June 8, 2026

2025-CRW-1019

**Re: Addendum No. One (1)**  
Snow Removal Equipment (SRE) Building  
3-54-0003-087-2025 (Design)  
3-54-0003-XXX-2026 (Construction)  
West Virginia International Yeager Airport (CRW)

DRAWING NO. A101  
SHEET NO. of

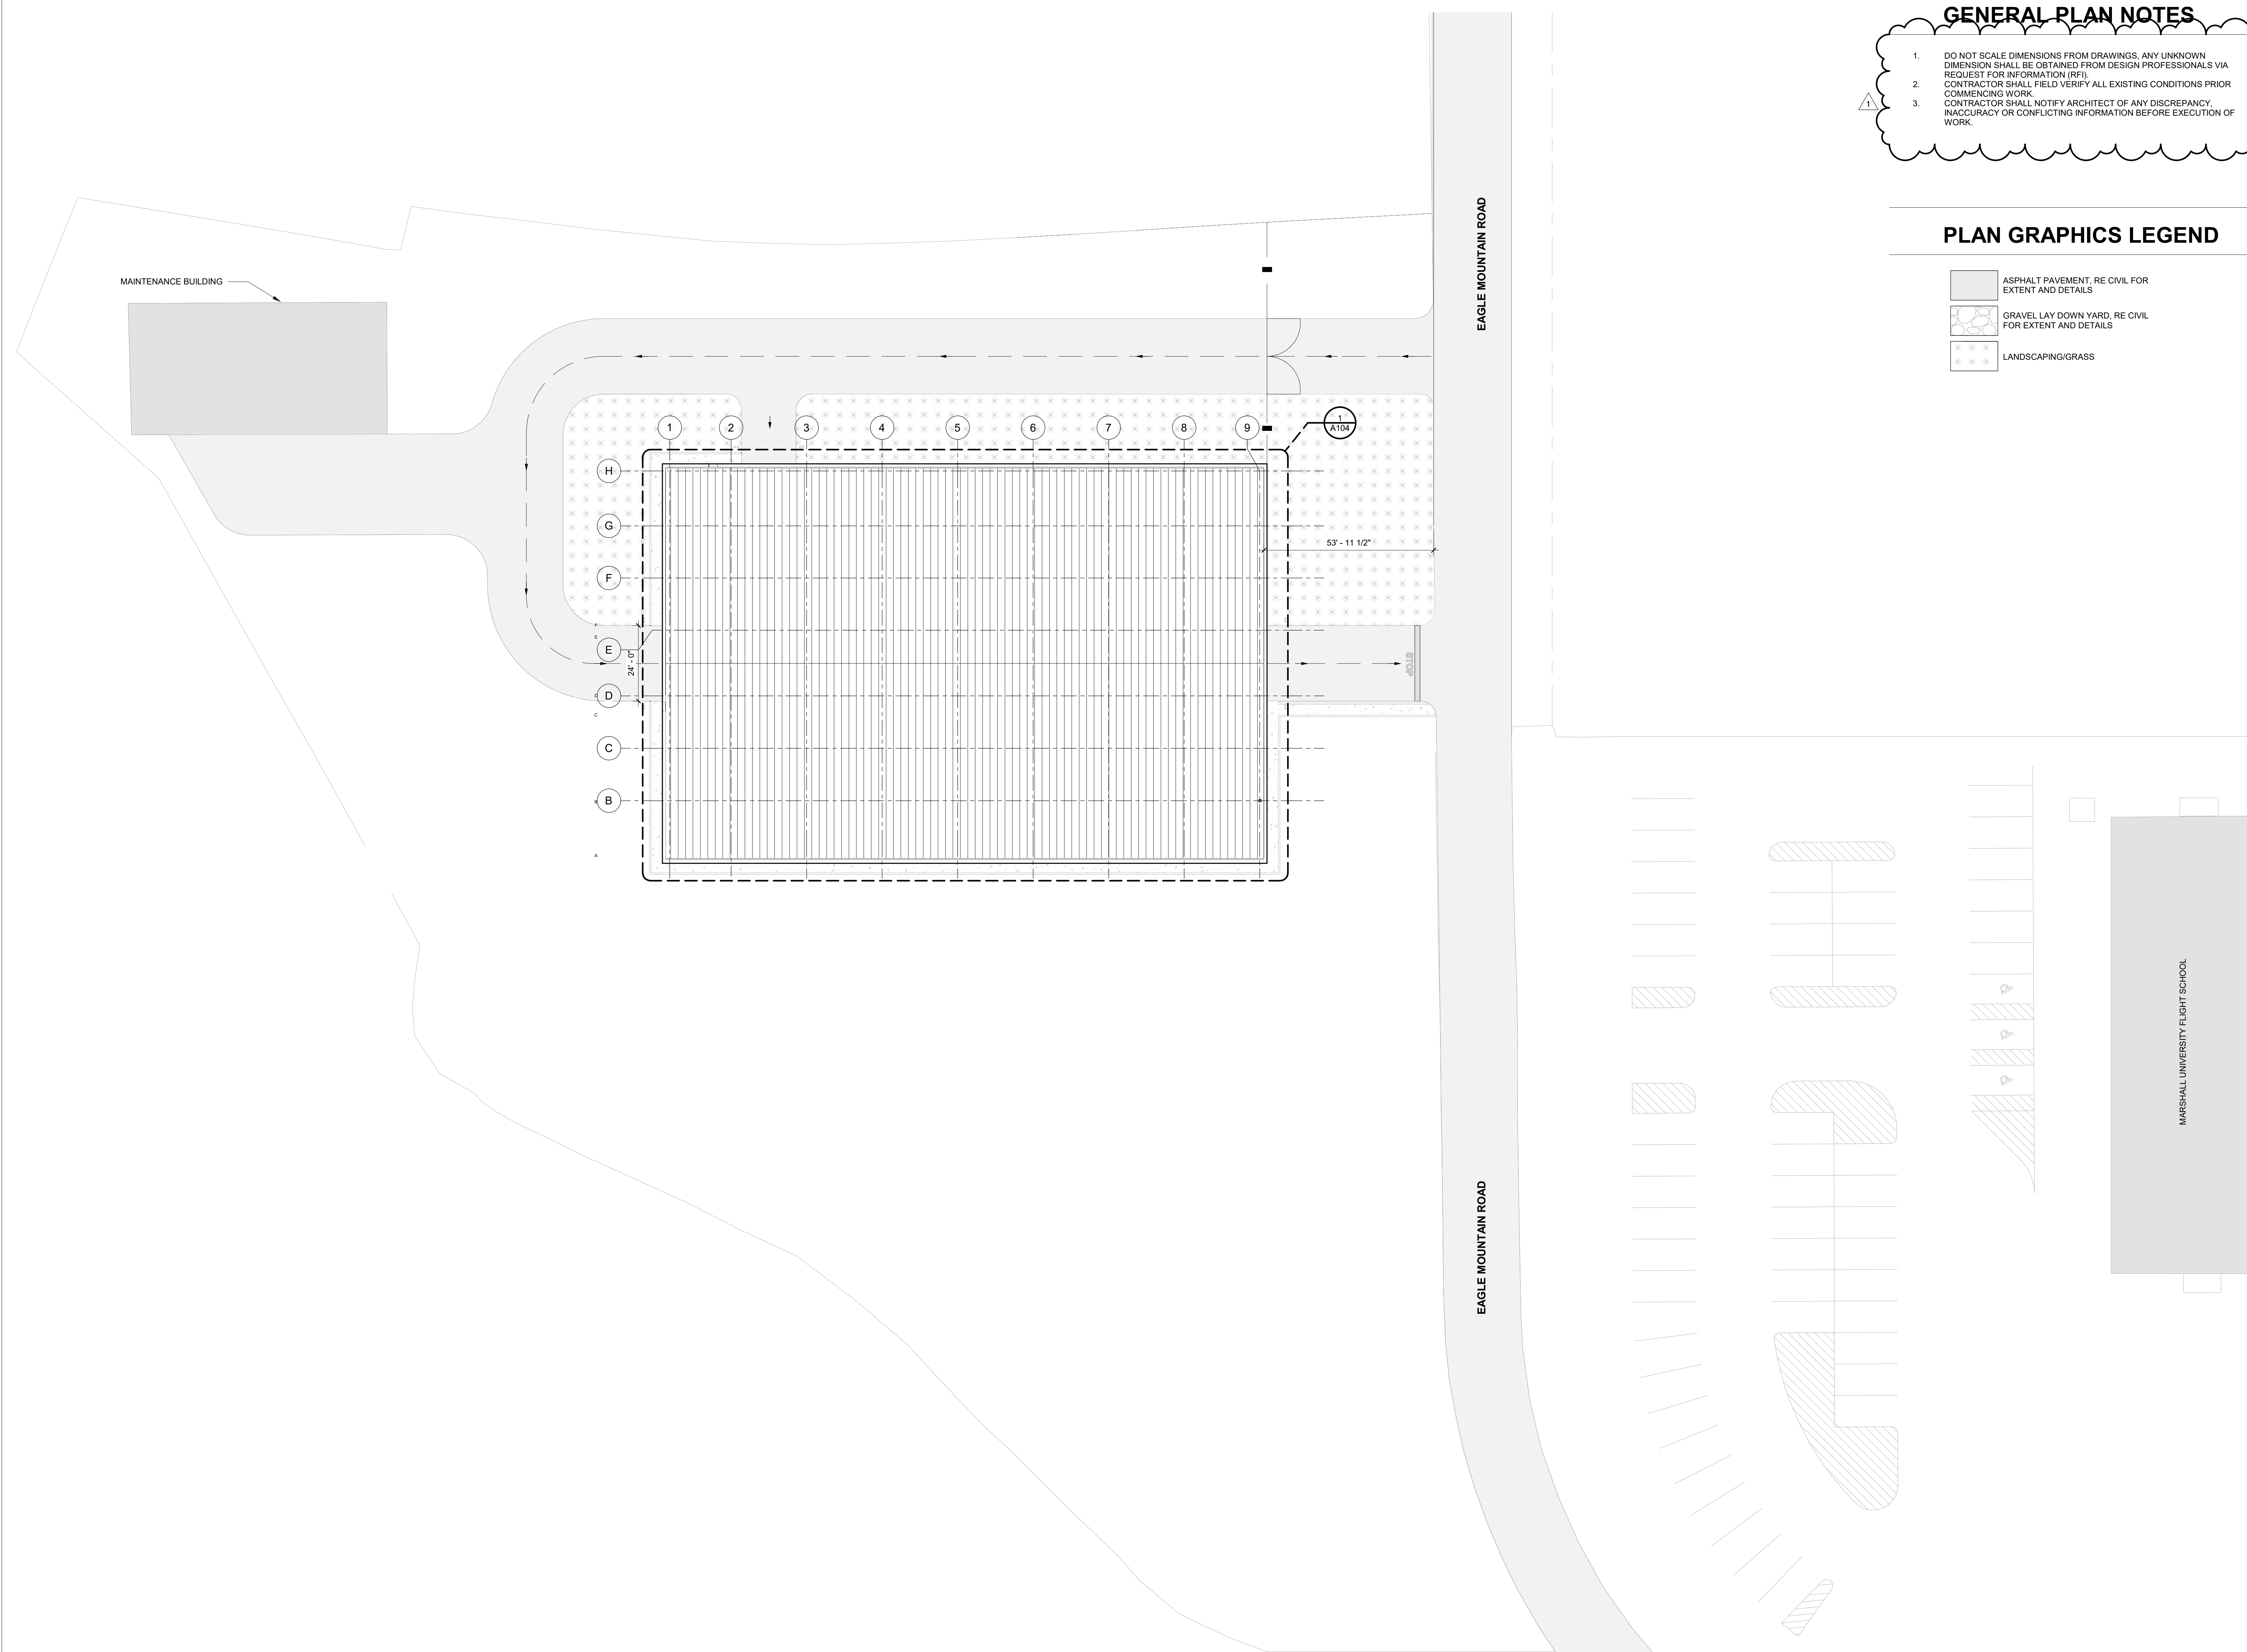
- 1.10 **REVISE** Drawing No. GI002
- 1.10.1 **REVISE** the Schedule of Quantities
- 1.11 **REPLACE** Drawing No. A101 with new A101 attached to this Addendum No. One (1).

- 1.11.1 **DELETE** Note reference #1
- 1.12 **REPLACE** Drawing No. A102 with new A102 attached to this Addendum No. One (1).
- 1.12.1 **DELETE** Note reference #1

EXTERIOR ELEVATIONS

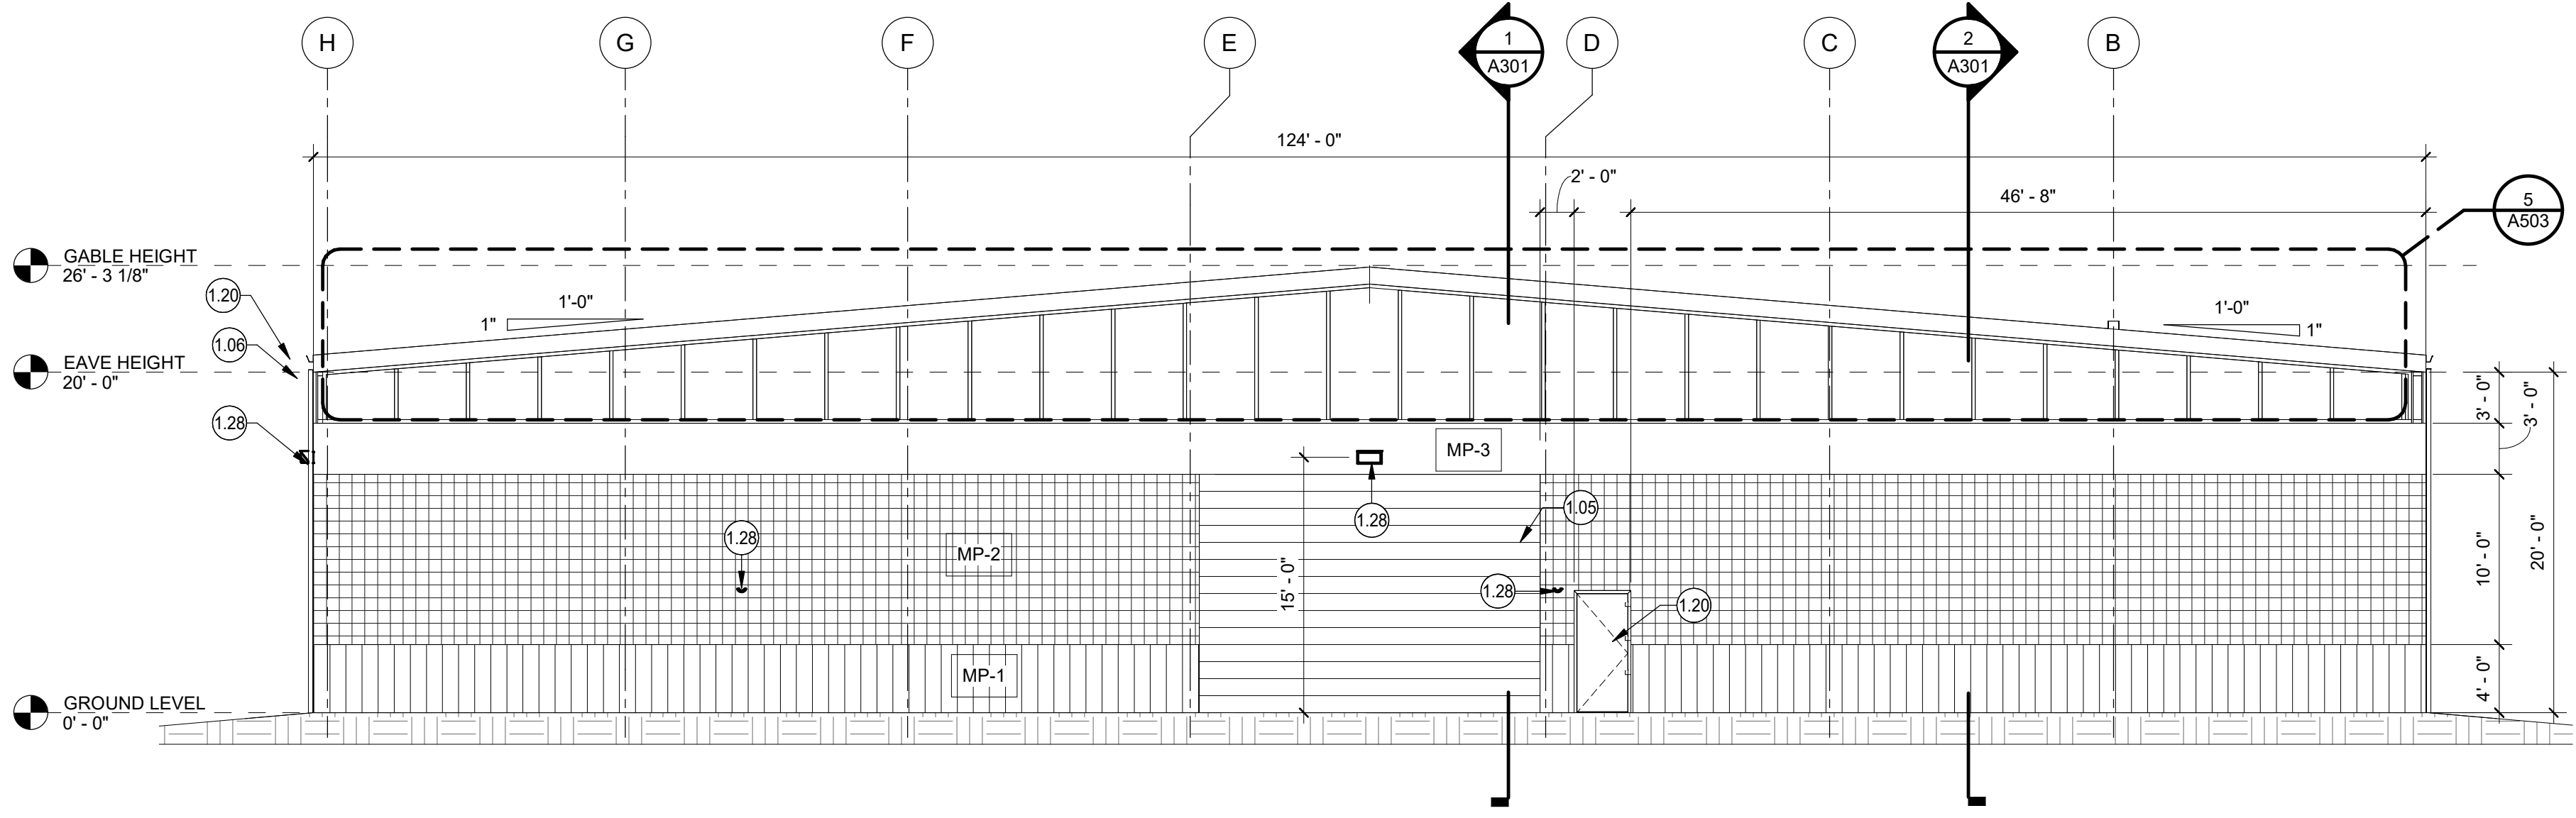
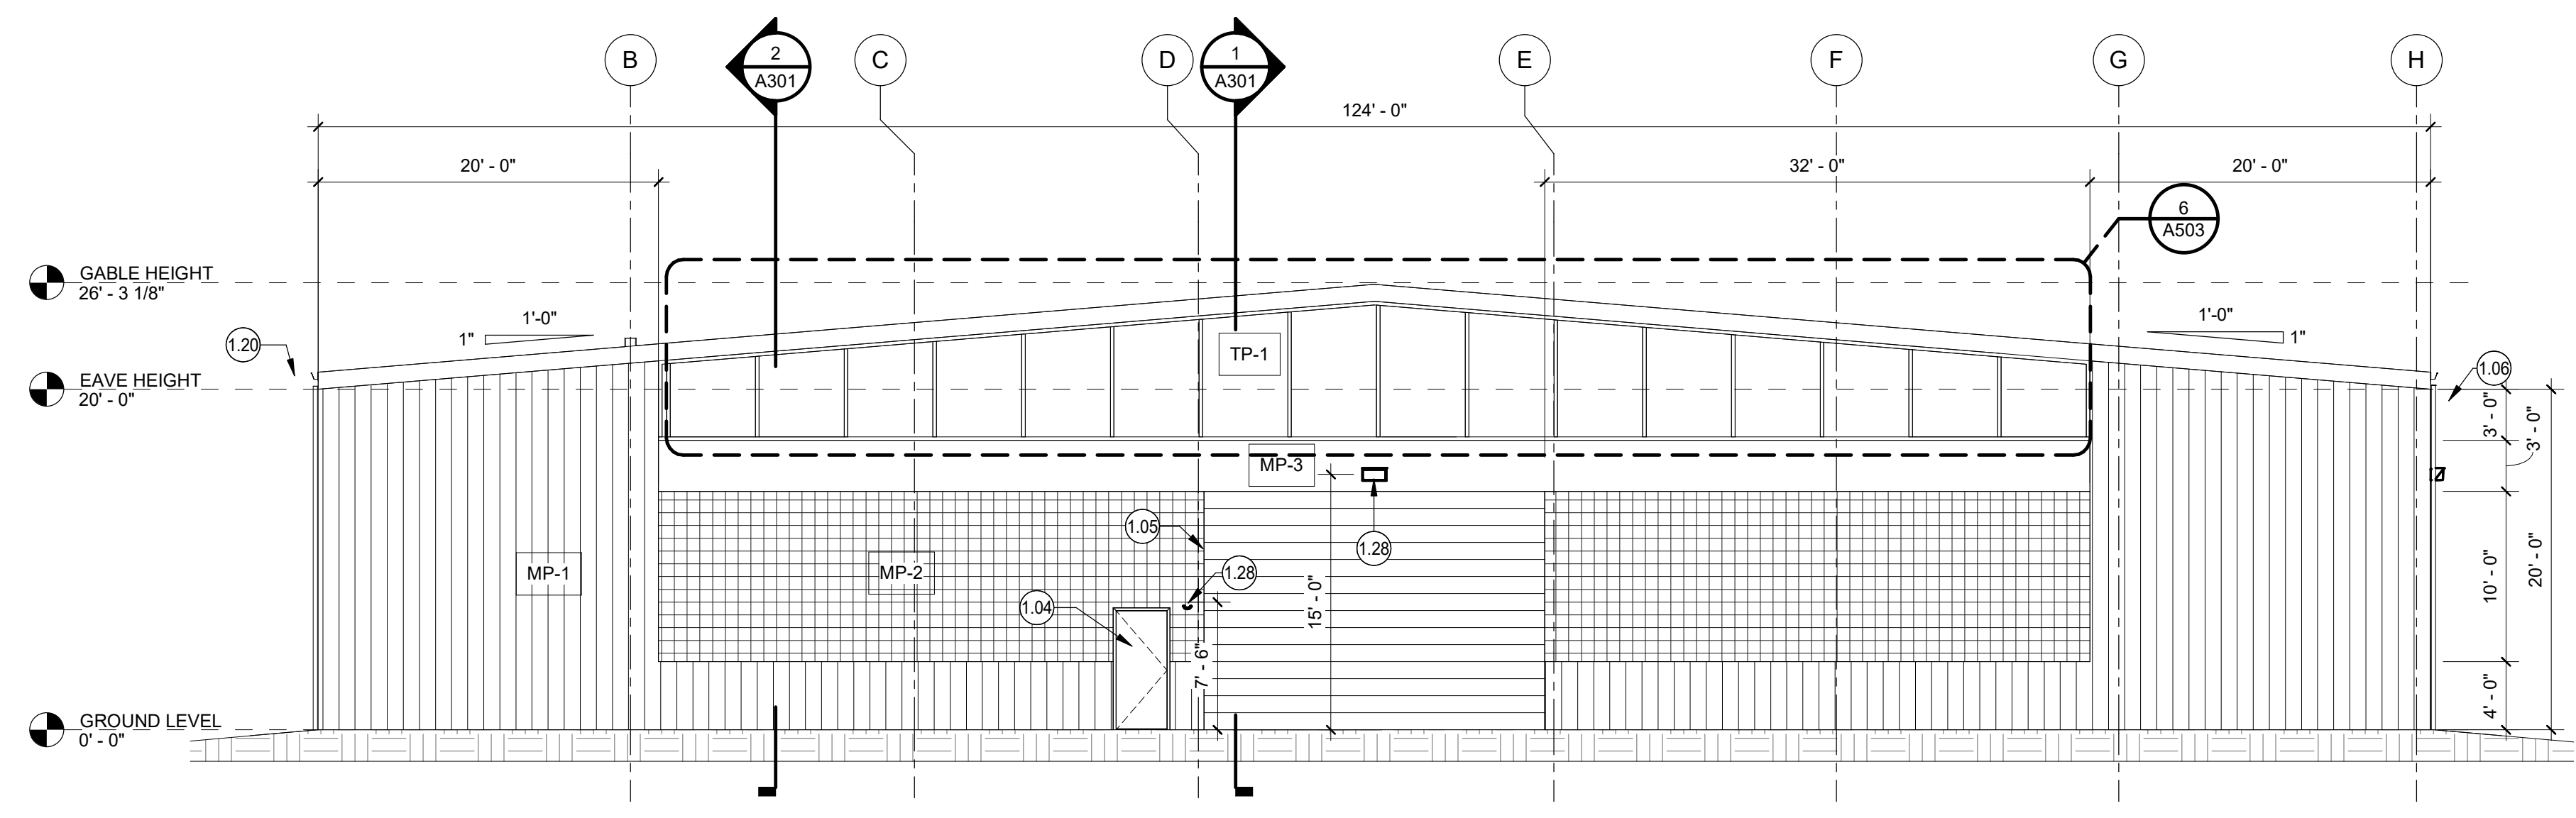
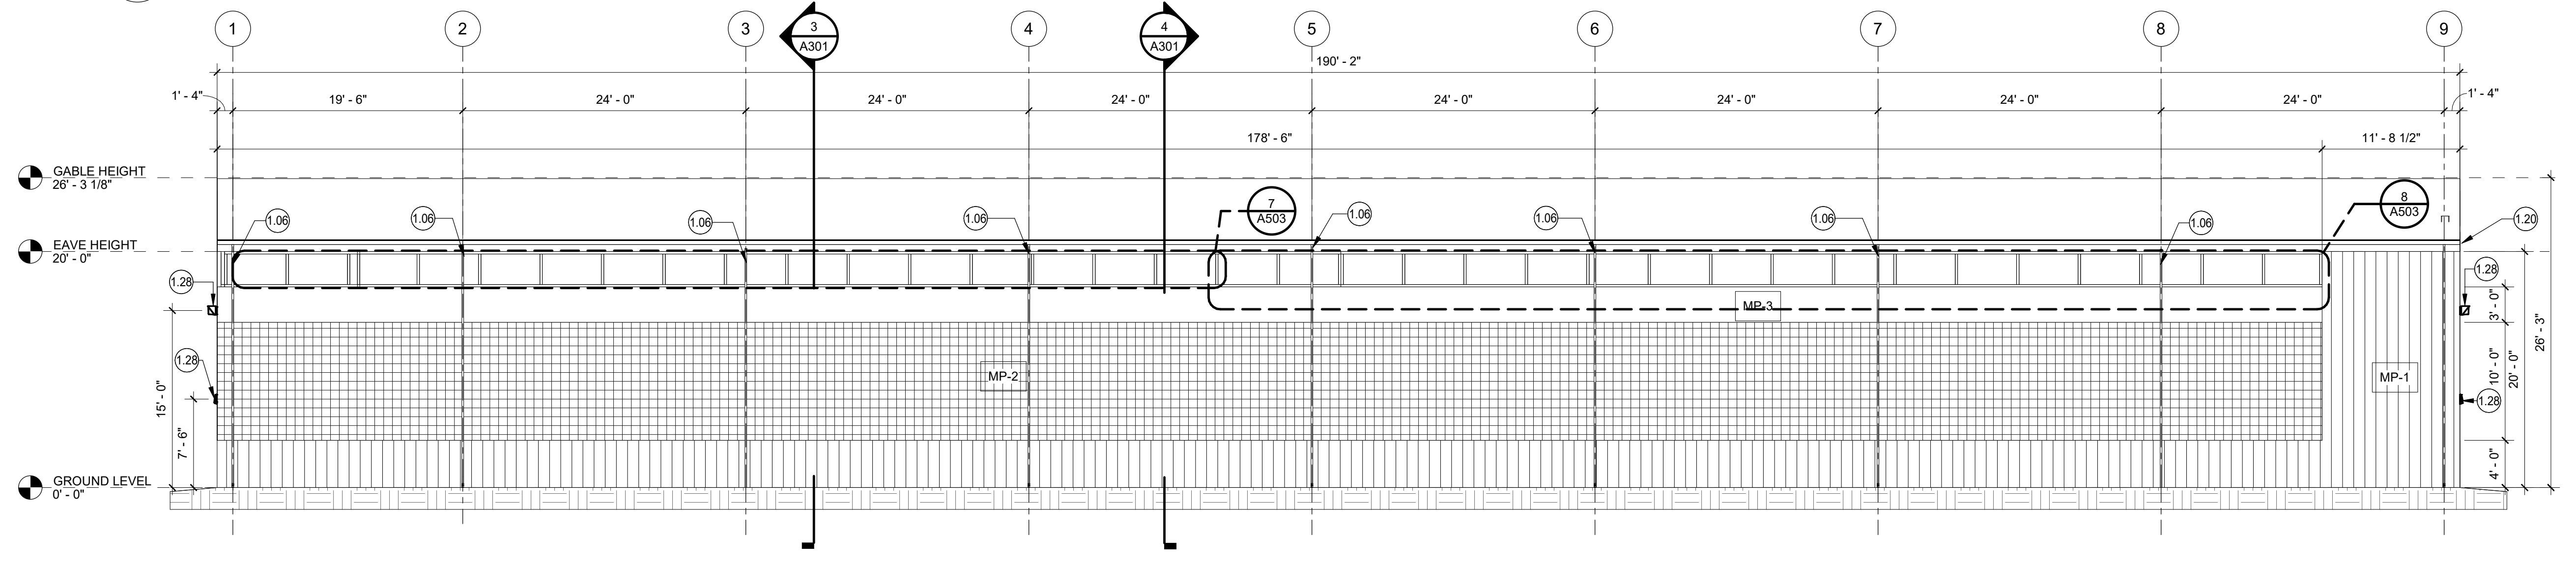
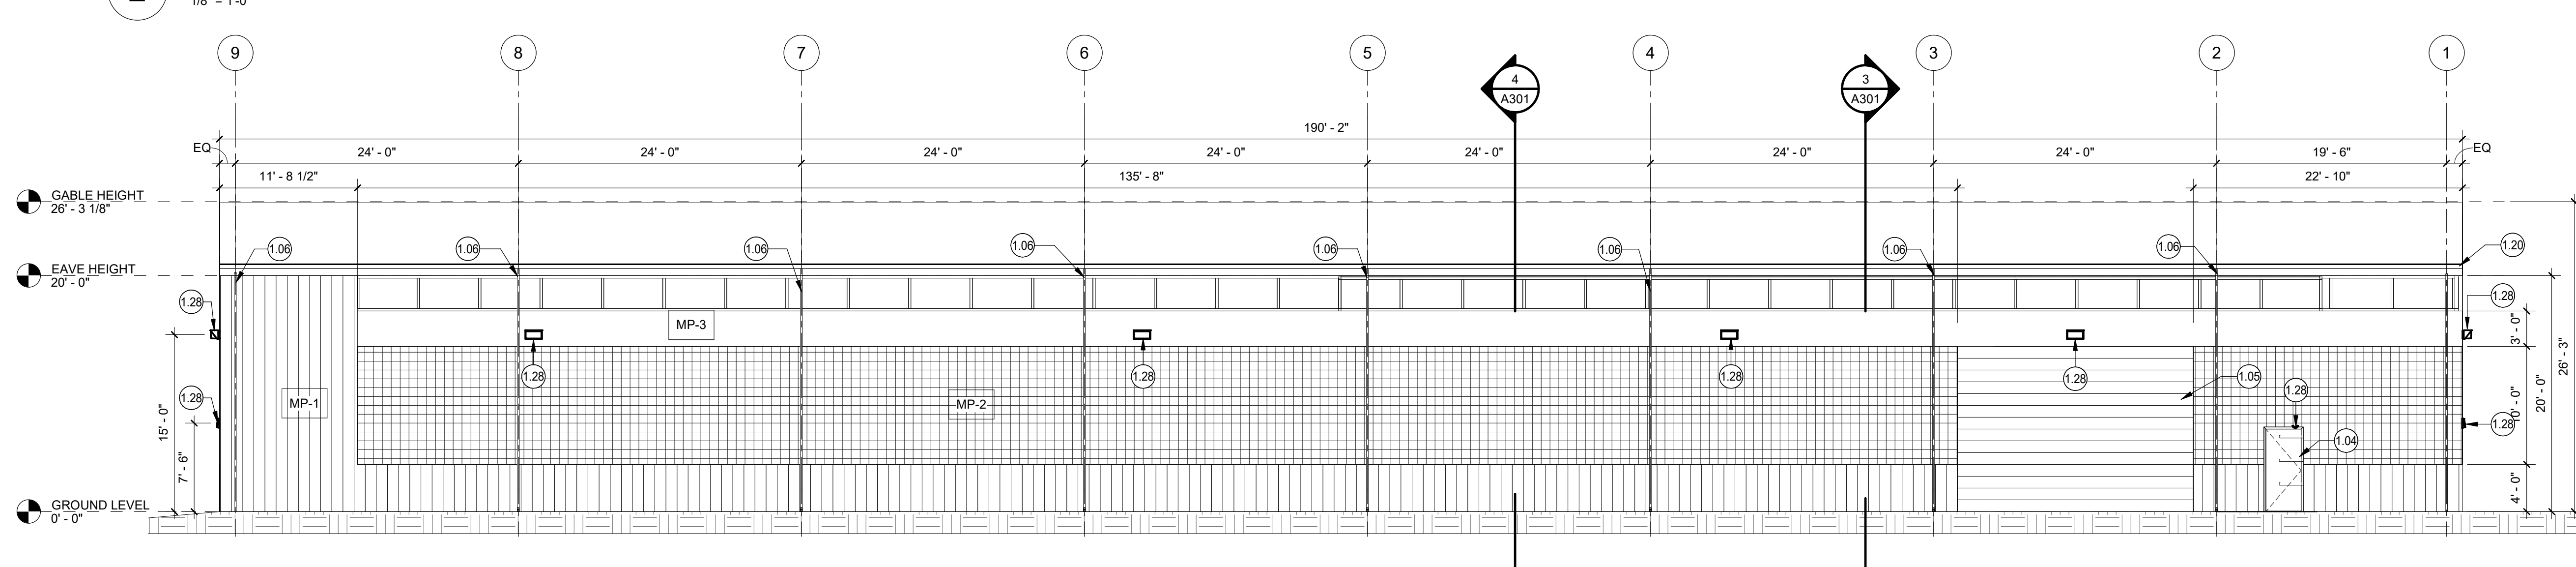
- 1.13 **REPLACE** Drawing No. A104 with new A104 attached to this Addendum No. One (1).
- 1.13.1 **DELETE** Note reference #1
- 1.14 **REPLACE** Drawing No. A201 with new A201 attached to this Addendum No. One (1).

- 1.14.1 **DELETE** Note reference #1
- 1.15 **REPLACE** Drawing No. A302 with new A302 attached to this Addendum No. One (1).
- 1.16 **REPLACE** Drawing No. A303 with new A303 attached to this Addendum No. One (1).
